RE: City of Lakeland--C.D. McIntosh Power Plant, Unit No. 3
Proposed Agreement to Modify Site Certification--PA-74-06

CITY OF LAKELAND
McIntosh Unit No. 3

Description of Amendments to Site Certification Application

PROPOSED AGREEMENT FOR MODIFICATION OF SITE CERTIFICATION

FIG. 8 MPS-75 PULVERIZER EXPECTED PERFORMANCE
(NOT CORRECTED FOR MOISTURE)

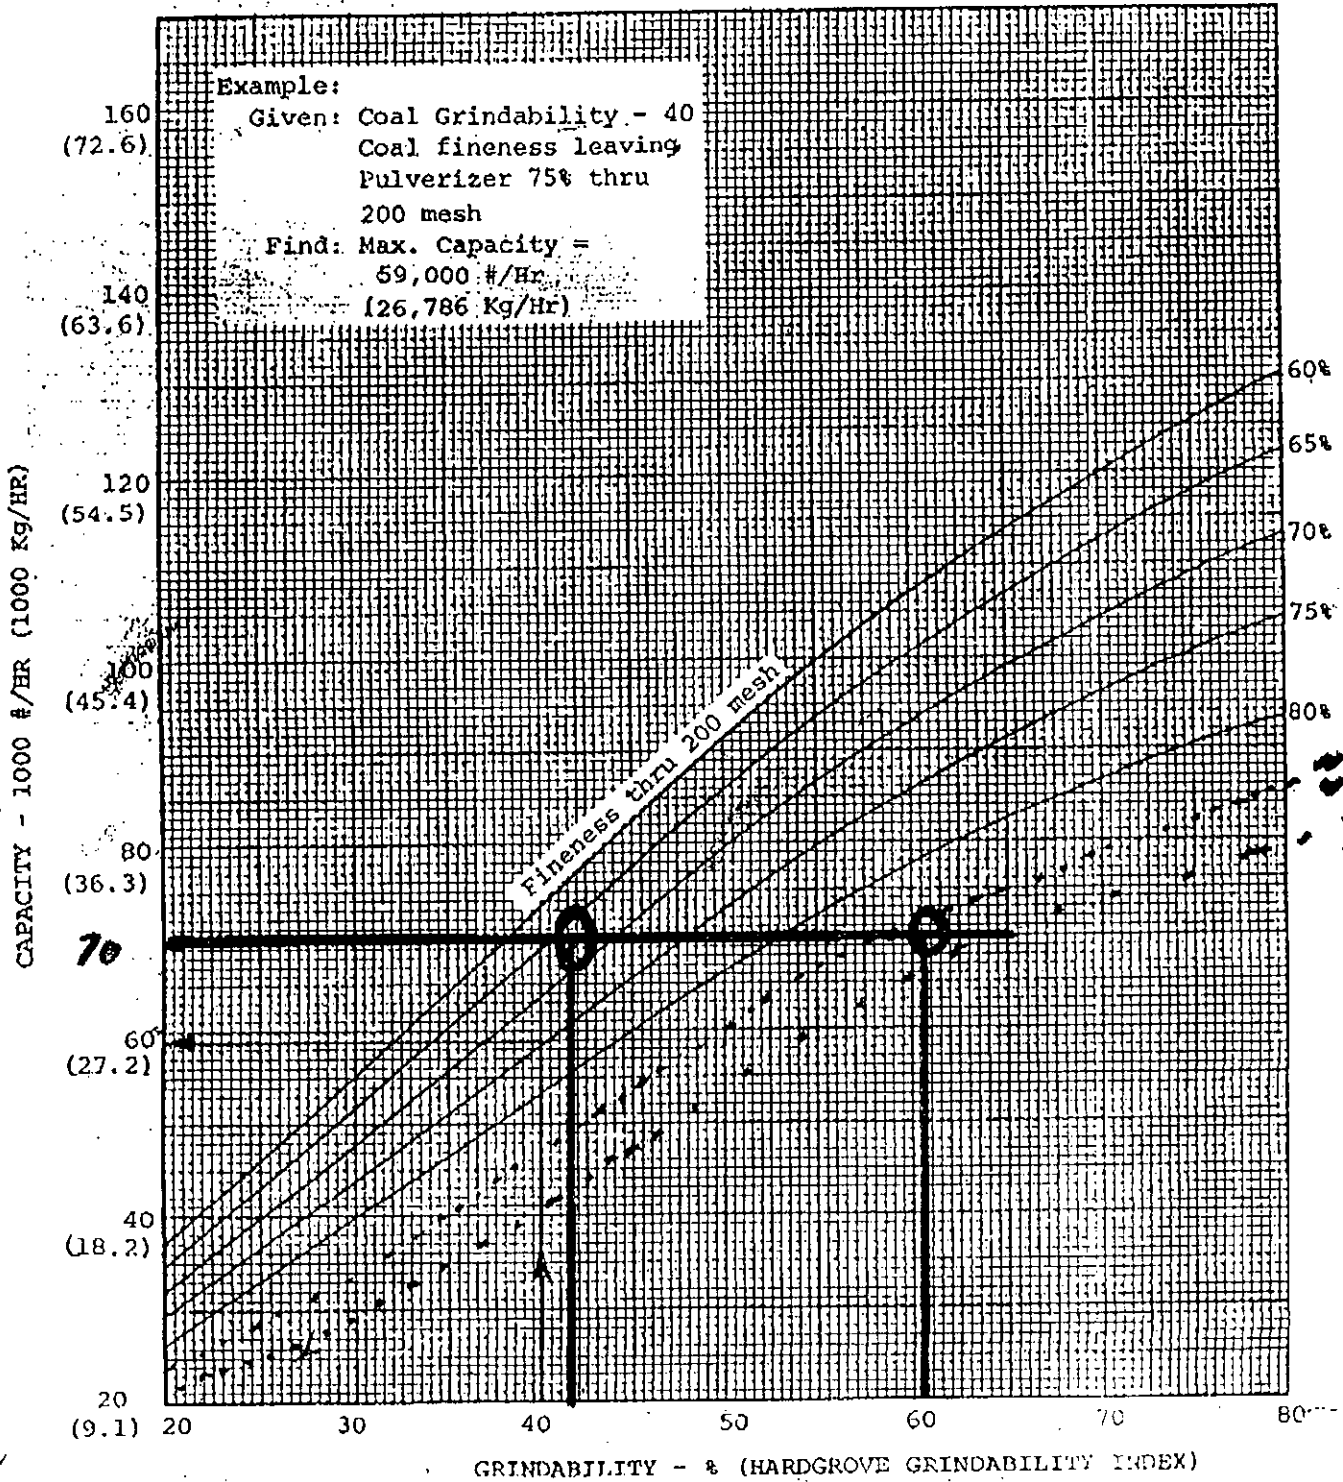
Fuel Flow Rates--Similar to the heat input rate issue, the fuel flow rates for McIntosh Unit No. 3 that were provided in the application need to be adjusted to reflect the actual maximum fuel flow rates experienced at Unit No. 3. These slightly higher fuel rates are needed to produce the same megawatt output of 364. As with the adjustment to the heat input rate, the

The application has been revised to reflect the actual maximum heat input achievable by the unit, as well as the actual fuel flow rates experienced. These higher rates are needed to produce the same megawatt output of 364.
